CANAL REPLACEMENT PROJECT, CEQA MND ADDENDUM NO.6, COMPLETION OF SEGMENT 5

SUBJECT: APPROVE CONTRA COSTA CANAL REPLACEMENT SEGMENT 5 PROJECT CHANGES

**CANAL REPLACEMENT PROJECT
CEQA MITIGATED NEGATIVE DECLARATION (MND)
Addendum No. 6
Completion of Segment 5
October 2022**

Groundwater Dewatering Plan Map

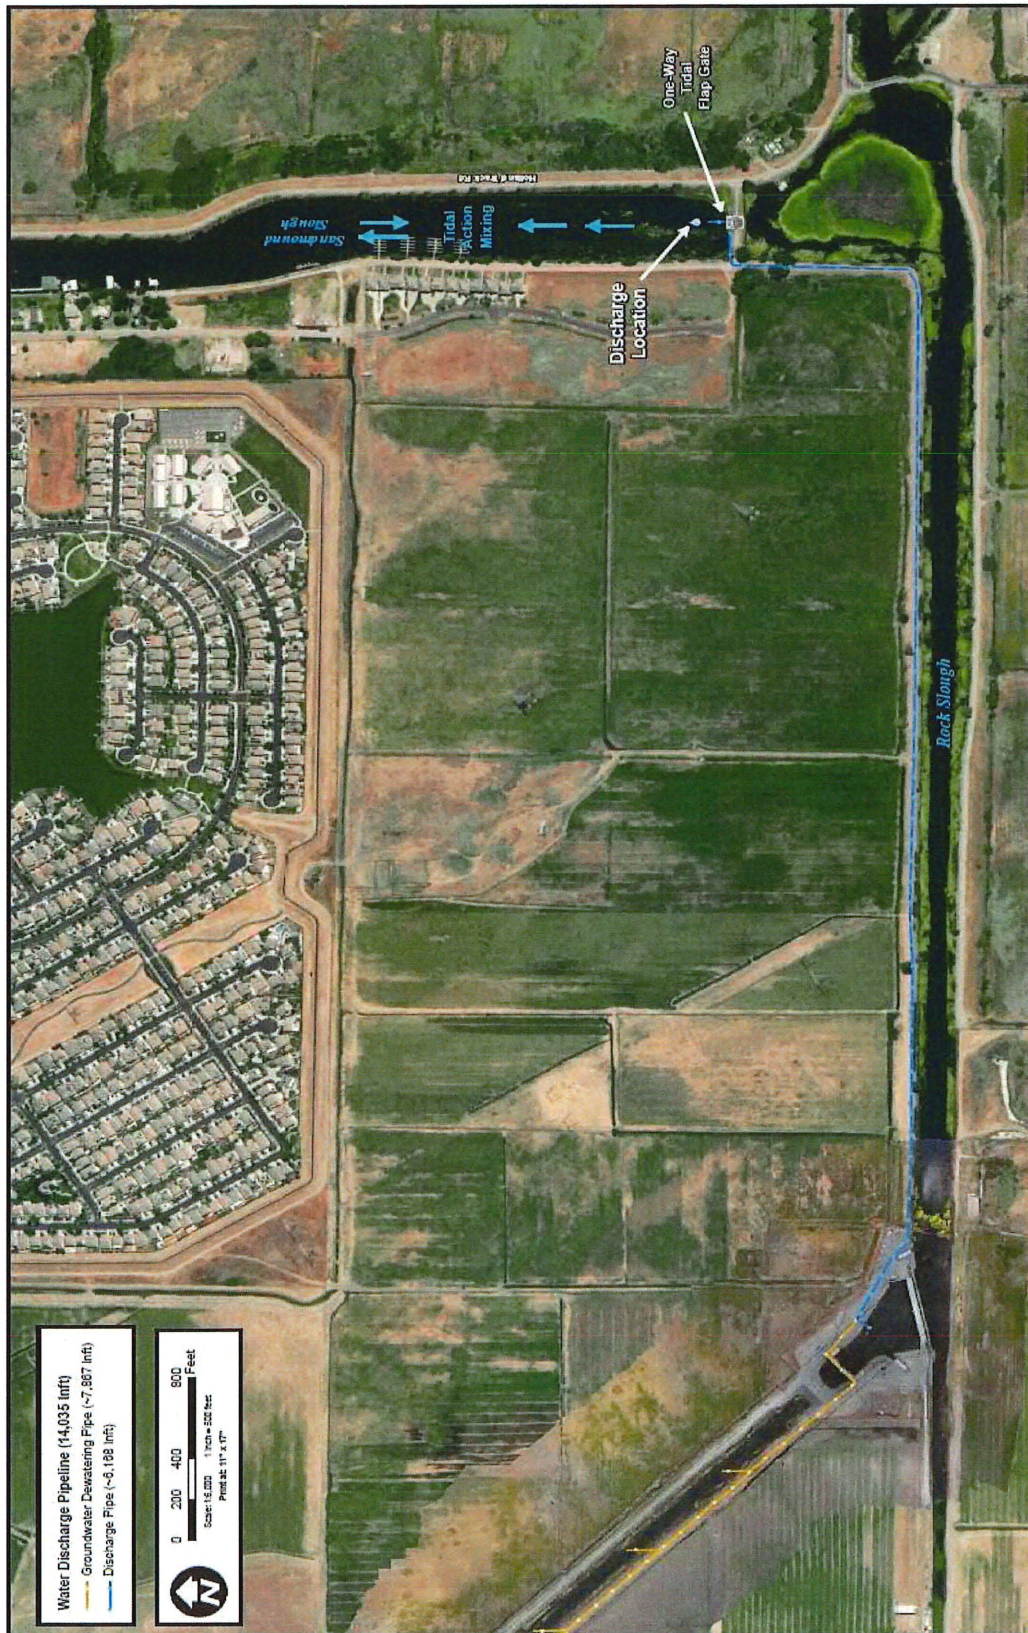
1. Adjusted Groundwater Dewatering Plan: Groundwater will be mixed with dilution water immediately downstream of the Rock Slough Fish Screen and then carried by a pipeline along the existing Rock Slough levees and discharged on the north side of the Sand Mound Slough tide gate (see Attachment 2).

Figure 6: Alternative ACD-TI Permitted Staging for Areas Segment 5B Construction
Contra Costa Canal Replacement Project
Addendum #6

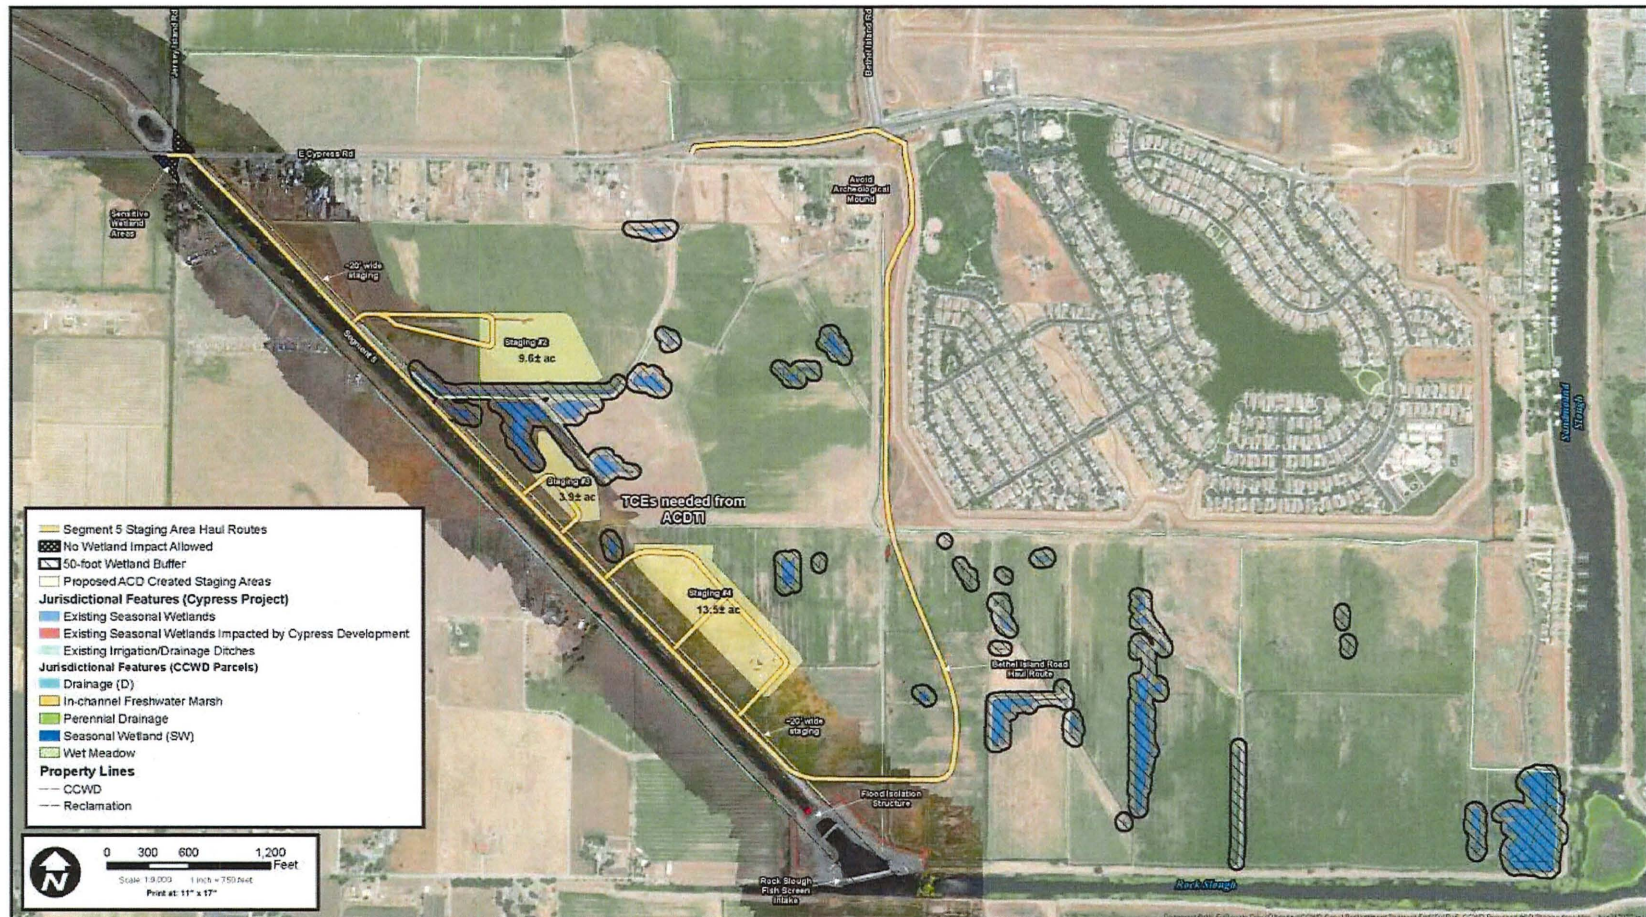
An alternative staging plan may be pursued that doesn't require the 200-foot TCE. In this circumstance ACD-TI will establish a 20-foot strip adjacent to the Segment 5 right of way and three interior staging areas, as part of their development grading, that can be accessed via temporary roads on ACD-TI property. Figure 5 illustrates the four planned ACD-TI established construction staging areas and temporary construction roads.

The 20-foot strip would be used for project laydown and staging, while the three interior areas would be used to support the storage of dirt during construction. ACD-TI intends to accept the soils removed from the unlined Canal on the three staging areas and provide CCWD with 29,500 cubic yards of fill material along the 20-foot strip. After the canal soils have dried, ACD-TI has indicated that they intend to reuse the soils according to their project specific requirements.
